SSD-61000021 – Objection – 146 Arthur St, North Sydney - Build-to-Rent

**SSD-61000021 – Objection – 146 Arthur St, North Sydney -
Build-to-Rent**

Planning Package – 146 Arthur Street Objection

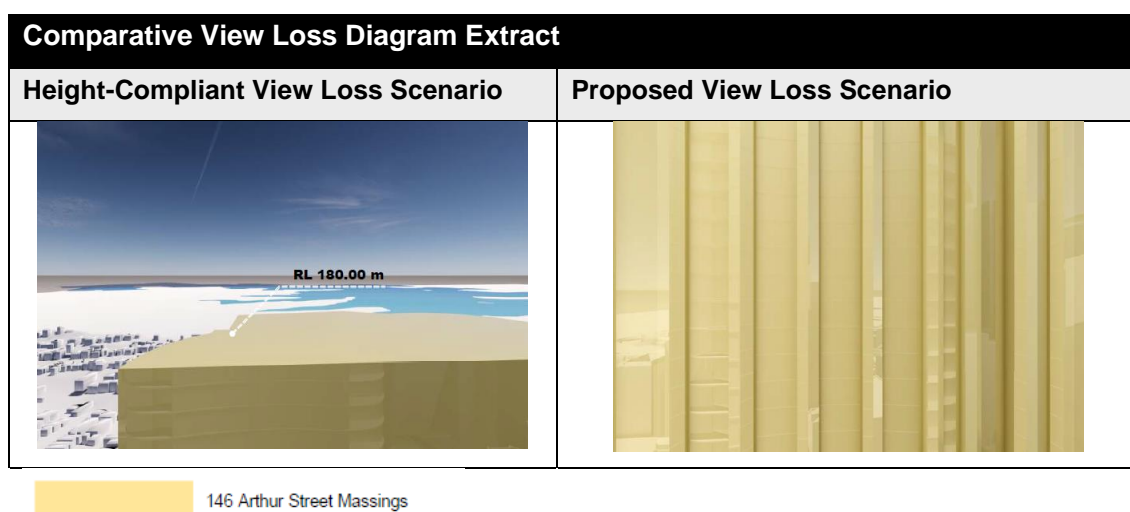
Below is a view loss diagram depicting the loss of our client's view assuming a height compliant development as against the height of the proposed development. As is evident from the image, there is an absolute loss of significant views.

The Proposed Development will obscure approximately 10 additional levels of east-facing residences on 153-157 Walker Street, once redeveloped. Many of these would be total, otherwise unobstructed views of Sydney Harbour, including the Bridge and Opera House. Most of these views, as indicated in our client's request for SEARs, would be from living areas, which are to be assessed more sensitively than those from other parts of a dwelling (*Tenacity* at [28]).

The impact on views could be mitigated by reducing the scale of the Proposed Development, specifically the height of the proposed tower form, to comply with clause 4.3 of the LEP. In this regard, we refer to the recommended massing reductions that are outlined at the conclusion of this submission.

View 1 Comparison Views – Compliant 146 Arthur Street Vs Proposed 146 Arthur Street

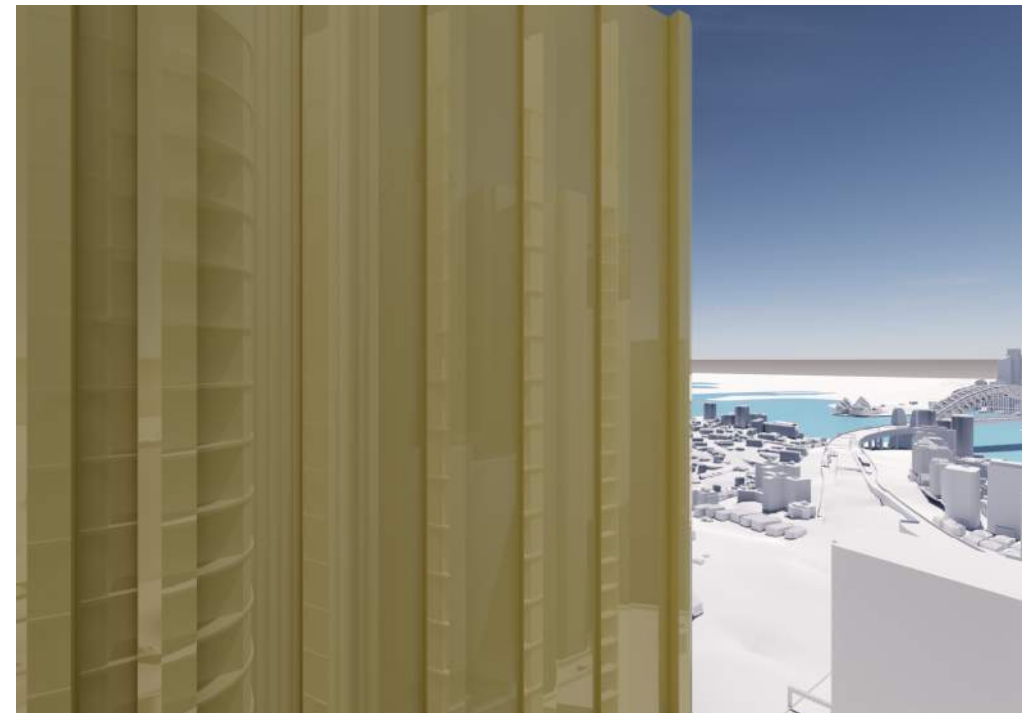
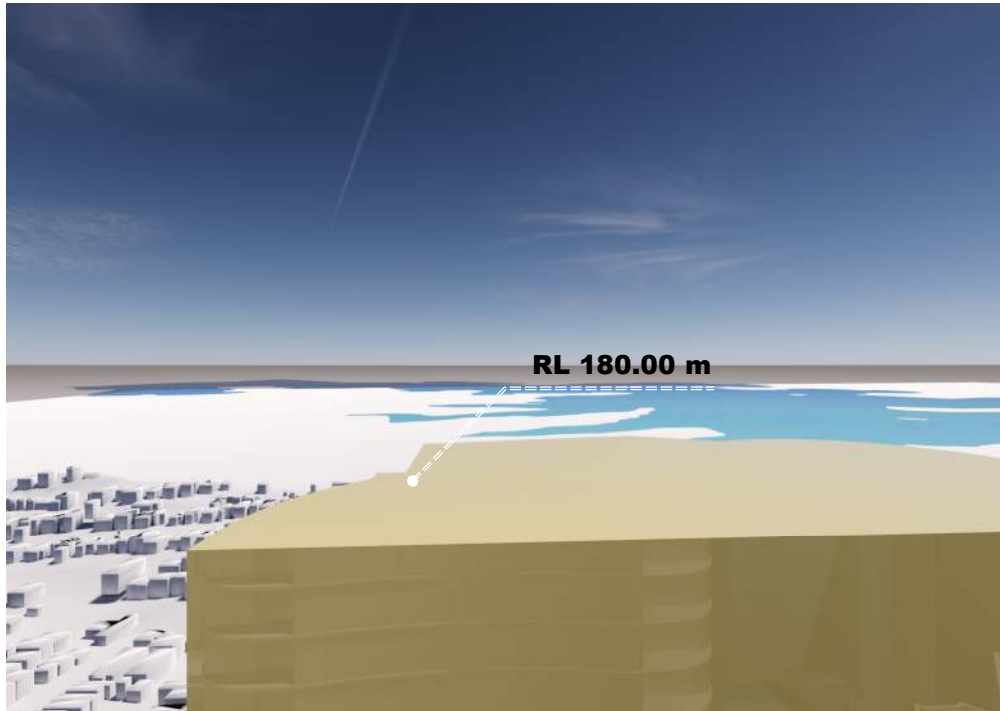
View looking to Harbor Bridge and Opera House – 146 Arthur Street - Compliant LEP / DCP Envelope

View looking to Harbor Bridge and Opera House – 146 Arthur Street – Proposed Design

-  146 Arthur Street Massings
-  Extent of view blockage of Proposed Design

Solar Access Study

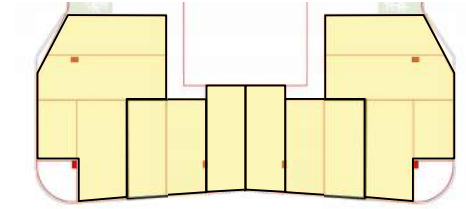
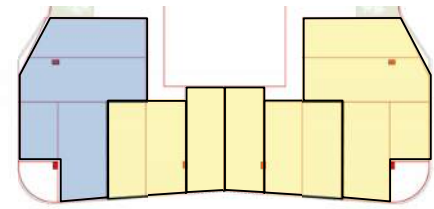
The study reveals that the proposed massing for 146 Arthur Street results in an increased extent of overshadowing on 155 Walker Street.

This additional overshadowing reduces the direct sunlight hours received by the building, potentially impacting the amenity, natural light access, and overall livability of its spaces.

Sun Eye View Study – 146 Arthur Street Proposed Design

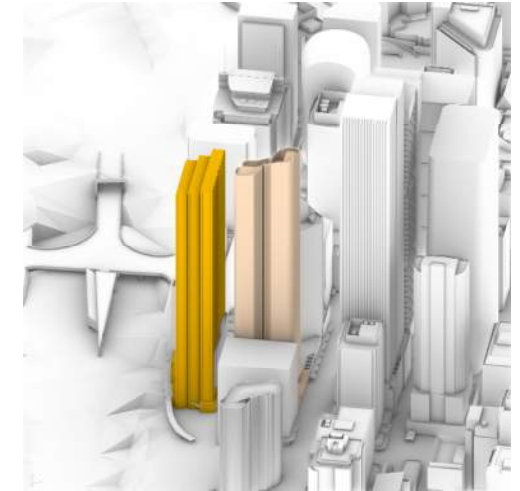
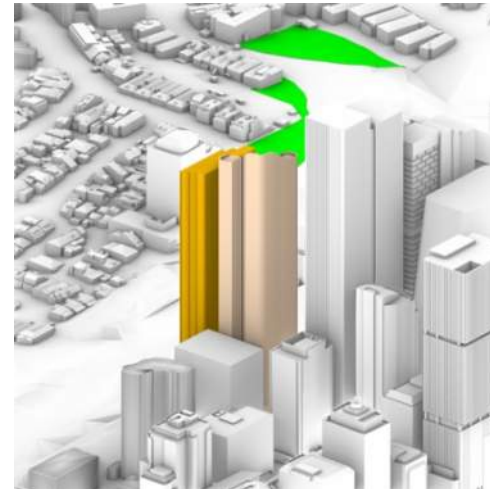
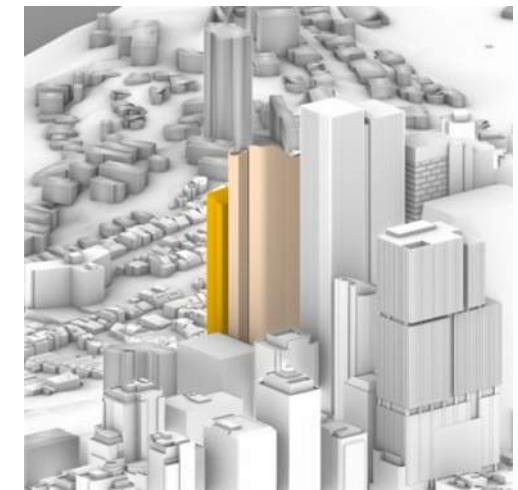
The proposed design scheme for 146 Arthur Street will result in additional overshadowing directly attributable to the proposed height variation and especially the Little Walker Street setback reduction. In a similar vein, this additional overshadowing is not reasonable to anticipate under clause 4.3 of the LEP. According to the Shadow Diagrams that were placed on Public Exhibition, the proposed scheme will cast additional shadows on 153-157 Walker Street during the early morning hours on 21 March, 21 June and 21 September.

Separation and Privacy Diagrams

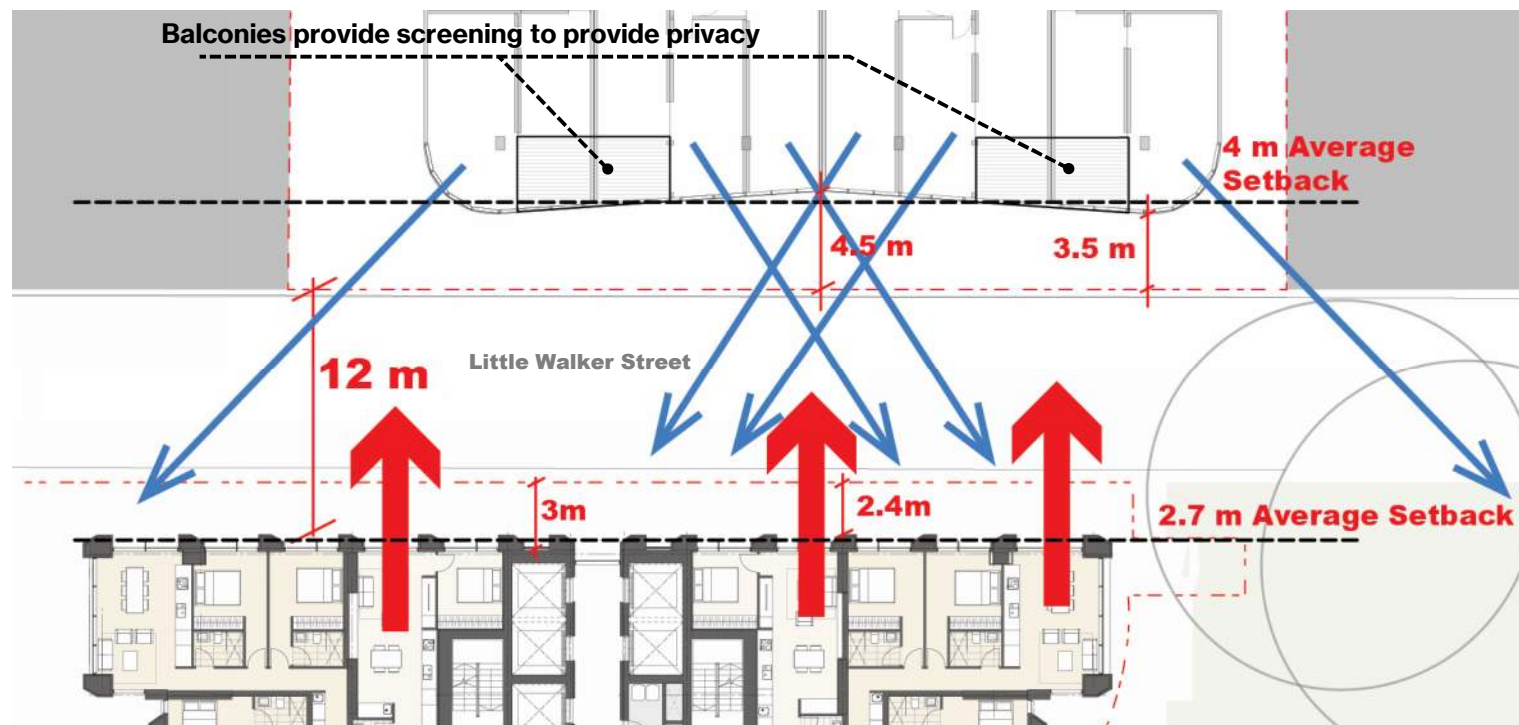
The Proposed Development's western façade is unarticulated. It contains no angulation and proposes to rely on vertical aluminium fins that direct, rather than divert, views towards 153-157 Walker Street. This is inappropriate if 153-157 Walker Street was to be developed as a purely commercial scheme and it is unacceptably inappropriate where it is to be predominantly residential, as outlined in our client's Request for SEARs.

- Direct Views from living room to 155 Walker Street;
- No balconies to increase separation from bedrooms;
- Insufficient Average Weighted Setback to Little Walker Street (2.7m AWS)

146 Arthur Street: Insufficient Frontage and Public Domain Impact on Little Walker Street.

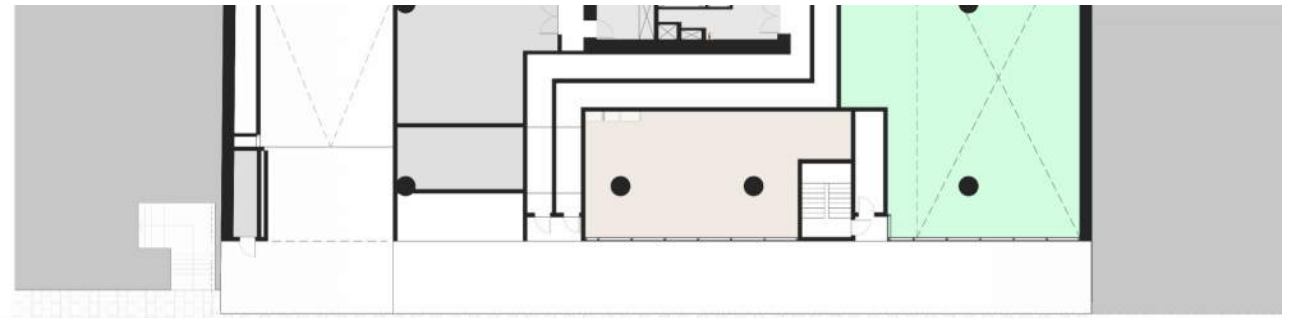
The proposed scheme for 146 Arthur Street provides inadequate frontage to Little Walker Street, conflicting with the principles set out in the North Sydney CBD Public Domain Strategy Plan.

The strategy emphasizes the need for cohesive, high-quality public domains that enhance the pedestrian experience and urban character, goals which are undermined by the minimal interface proposed in this development.

Additionally, the inclusion of a porte-cochère facing Little Walker Street disrupts the intended function of this public domain.

By directing vehicular traffic and servicing onto Little Walker Street, the proposal interrupts the pedestrian flow, diminishes the street's amenity, and conflicts with its intended role as a quieter, pedestrian-focused space within the urban fabric.

All servicing and vehicular access for developments along Arthur Street should be oriented toward Arthur Street itself, a major thoroughfare designed to handle such activities.

The Importance of an Appropriate Average Weighted Setback to Little Walker Street.

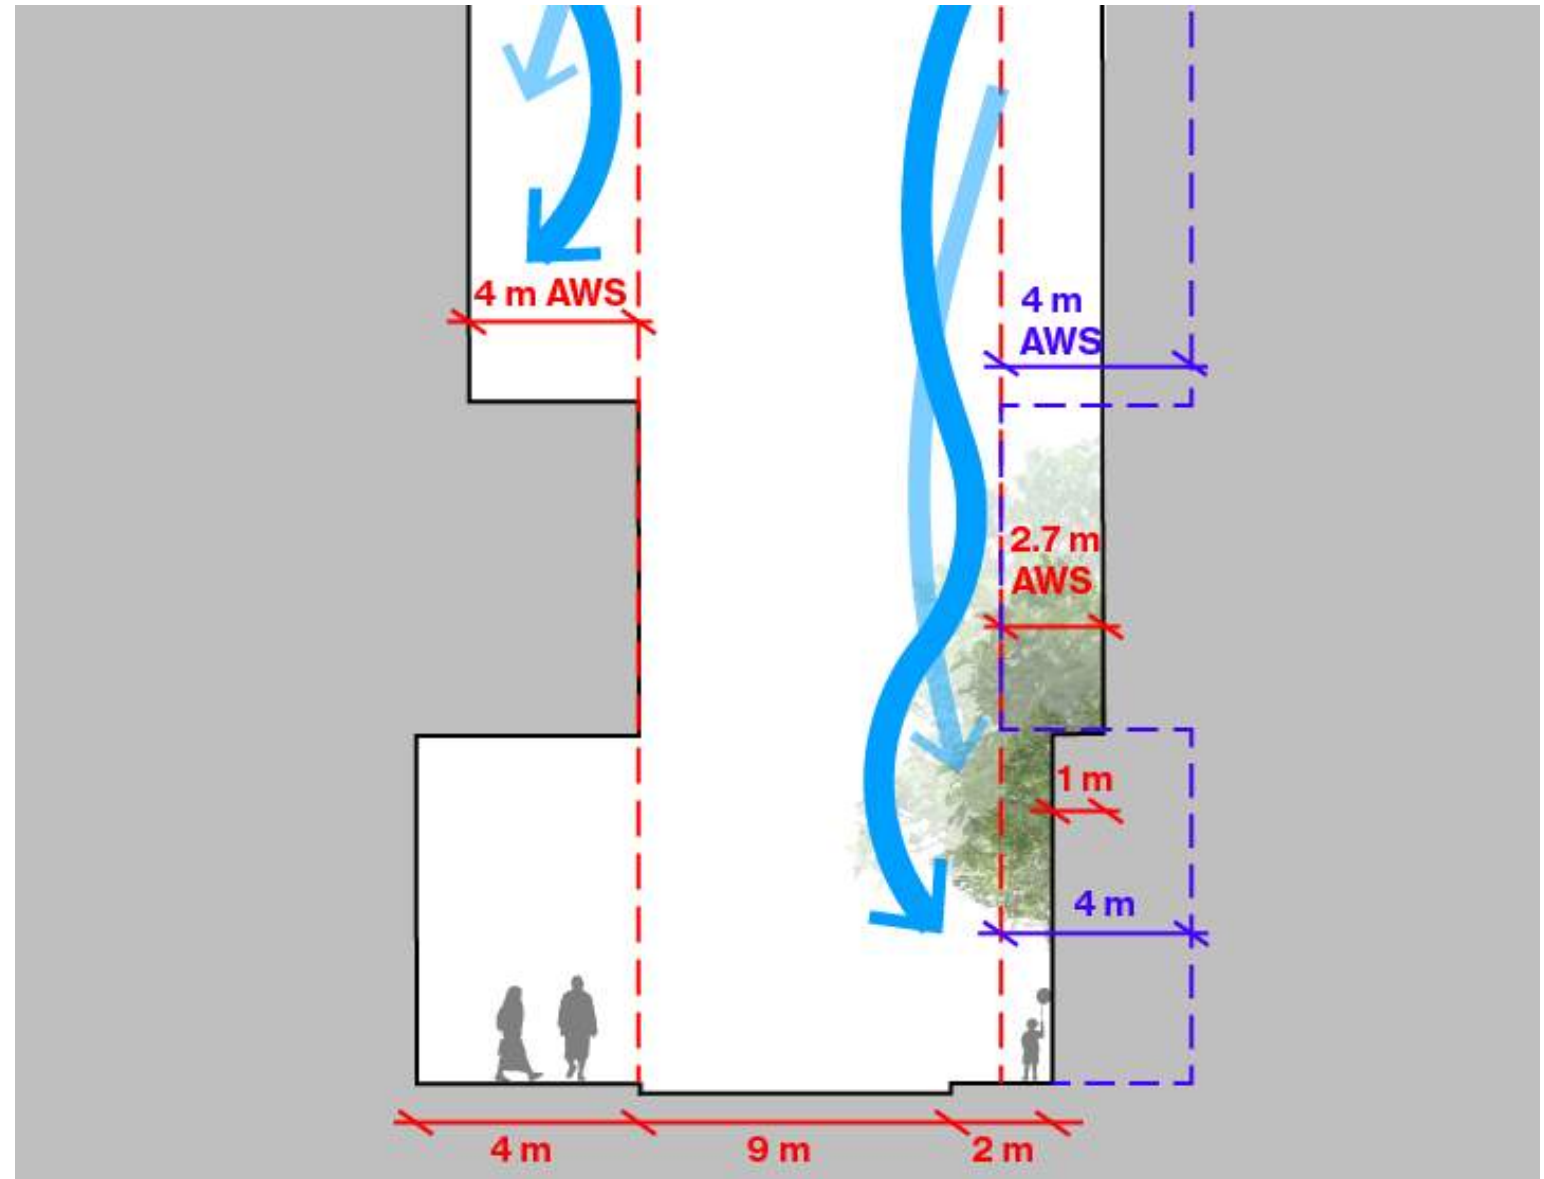
The proposed podium form, insufficient average weighted setbacks, and inadequate tower separation of 146 Arthur Street fail to achieve a high-quality urban design outcome, particularly concerning the amenity and pedestrian comfort of Little Walker Street.

The insufficient setbacks and limited tower separation create a sense of overbearing bulk along Little Walker Street, reducing opportunities for sunlight, openness, and visual relief.

Additionally, these deficiencies compromise wind mitigation, exposing pedestrians to accelerated wind flows often caused by unbuffered podium and tower designs.

- a 4m above-podium average weighted tower setback must be adopted along Little Walker Street;
- a 6m setback to Doris Fitton Park must be adopted. At minimum, this must be implemented in relation to the north-western aspect of the proposed tower form; and
- in the absence of sufficient environmental planning grounds to support the proposed height variation, the height of the proposal should be reduced to satisfy clause 4.3 of the LEP.

North Sydney Skyline

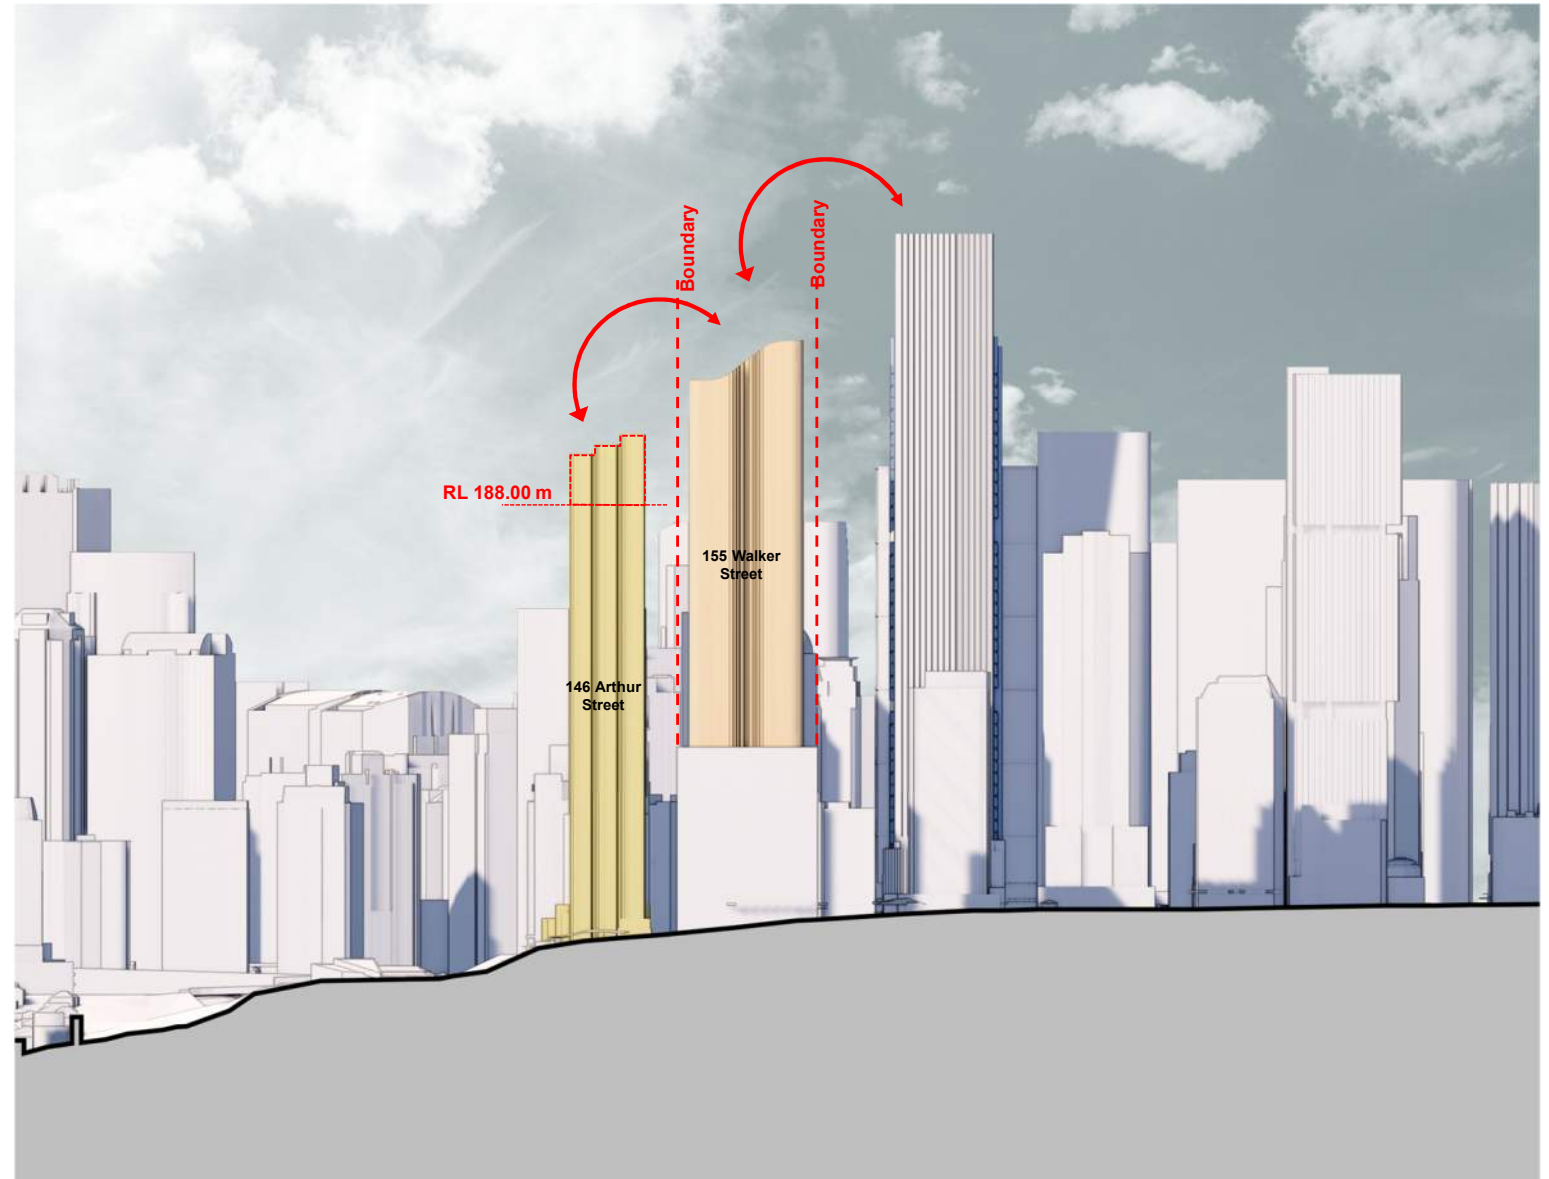
The proposed design of 146 Arthur Street, with its insufficient setbacks and additional height, fails to provide a positive contribution to the North Sydney skyline.

Appropriate setbacks are essential to ensure the transition between podium and tower forms, creating a harmonious relationship with surrounding buildings. However, the current design's limited setbacks result in a bulky and overbearing appearance, which disrupts the balance and cohesion of the skyline.

The additional height further exacerbates these issues by introducing an exaggerated vertical dominance that overwhelms adjacent structures. Instead of complementing the evolving North Sydney skyline, the proposal detracts from its visual harmony, appearing out of scale and inconsistent with the area's urban character.

To contribute positively to the skyline, developments must balance height with appropriate proportions, setbacks, and tower separation, fostering visual rhythm and ensuring that new projects integrate seamlessly into the broader urban context. 146 Arthur Street's design fails to achieve this balance.
